We would like to thank reviewer 1 for his/her constructive comments and suggestions.

Response: Added Germany to the title. New title: "Can TROPOMI-NO₂ satellite data be used to track the drop and resurgence of NO_x emissions within Germany between 2019 – 2021 using the multi-source plume method (MSPM)?"

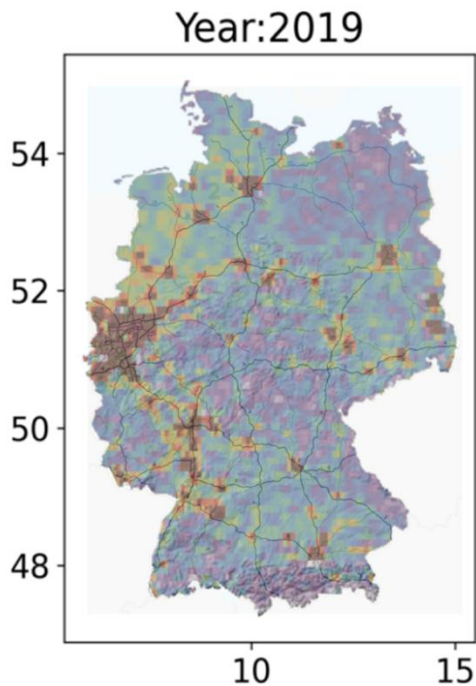
Line 394: You mention a noticeable drop in emissions around highways. Where I think this is not visible. There is probably a reduced signal in the region of the A2 highway close to the Ruhr area, but this isn't easy to disentangle since there are several power plants along the highway in this part. See comment regarding line 374. I would recommend removing the part about the highways here.

Response: See the response to the previous comment. We agree that at the location of the A2 highway we see a clear drop but also we are confident the signals from the A1 and A3 are visible. Actually plotting the road network on the emission estimates might show this more clearly to the reviewer:
